# **As-Built Baseline Monitoring Report**

Rough Horn Swamp Restoration Site Monitoring Year – MY00 2020 DMS Site ID Number 97005 DMS Contract 6596 SAW-2015-00952 and NCDEQ DWR 2015-0903

Rough Horn Swamp II Restoration Site DMS Site ID Number 100053 DMS Contract 7514 SAW-2016-02026 and NCDEQ DWR 2015-0903

Date:	May 12, 2020
To:	Kelly Phillips, DMS Project Manager
From:	Adam Spiller, Project Manager
	KCI Associates of North Carolina, PA
Subject:	MY-00 Monitoring Report Comments
-	Rough Horn Swamp DMS #97005, Contract 6596
	Rough Horn Swamp II DMS #100053, Contract 7514

# **As-built Plan Sheet**

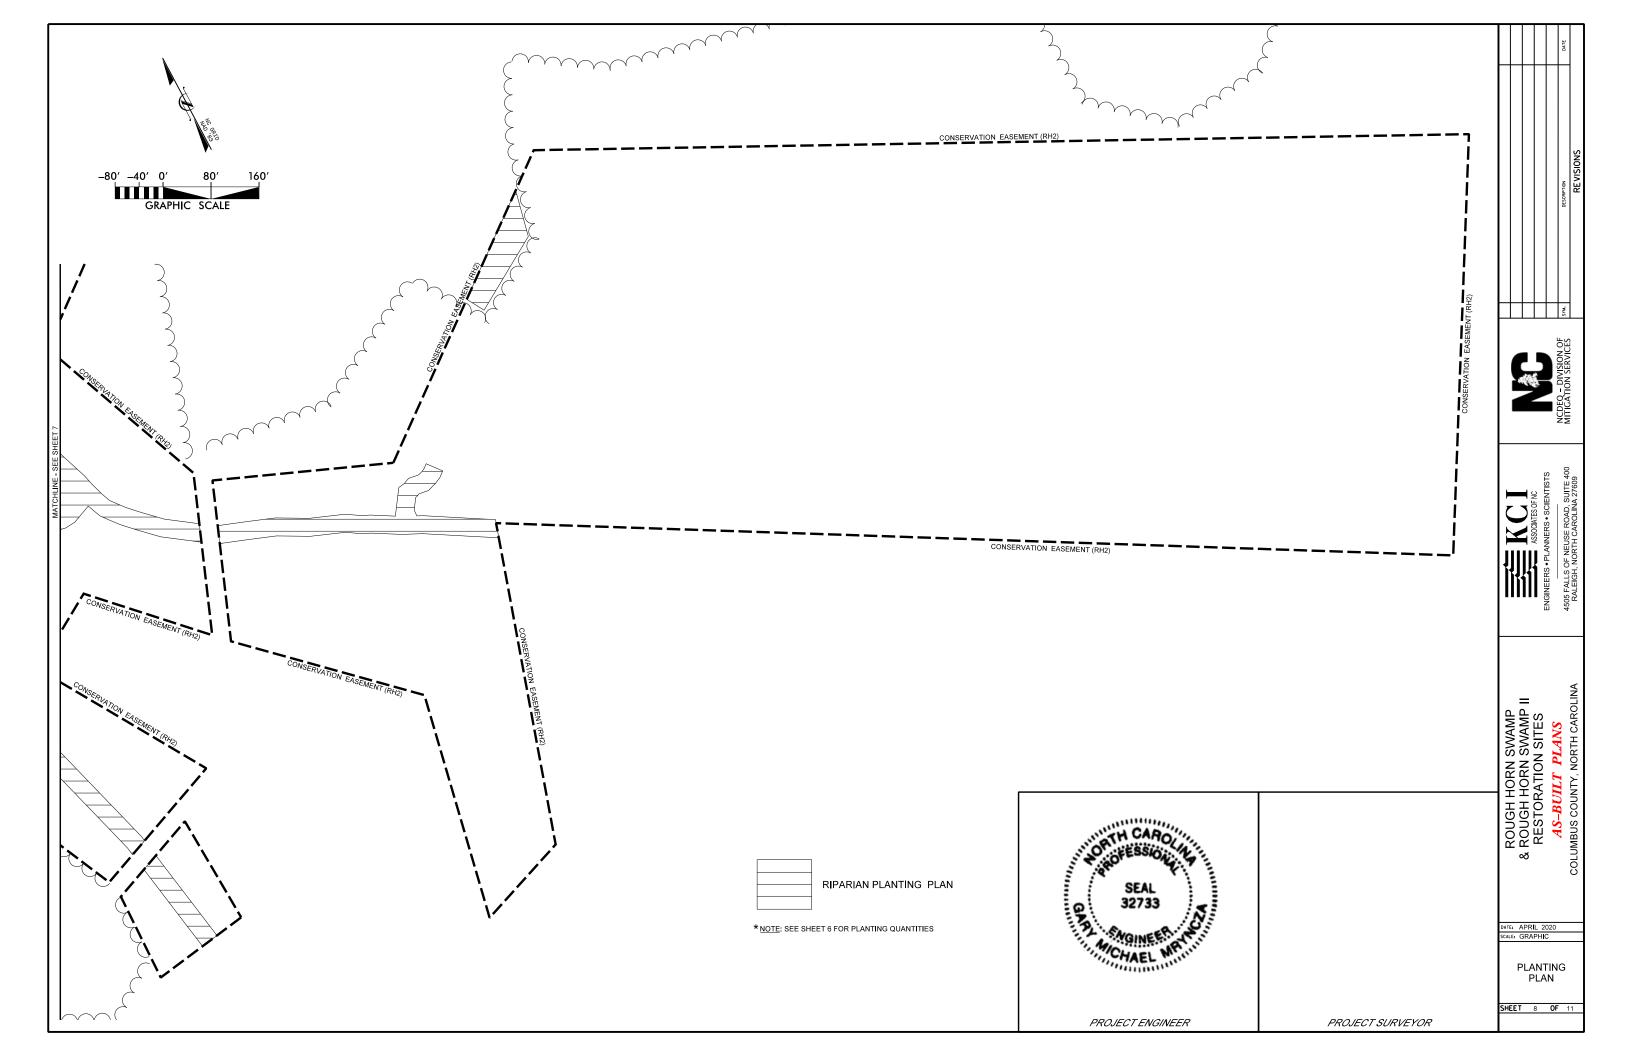
- 9. Provide justification why the ditch plugs were not shown on as-built plans. DMS observed that the ditch plugs were installed, but that layer was not on drawings. *KCI Response: Ditch plugs were inadvertently left off of the as-built plans. This error has been corrected.*

- Check the labels of topo on the As-Builts. There were some instances in the field where the label did not appear to make sense for the topo line. *KCI Response: Additional topo labels have been added to the as-built plans to clarify the elevations* of the topo lines.
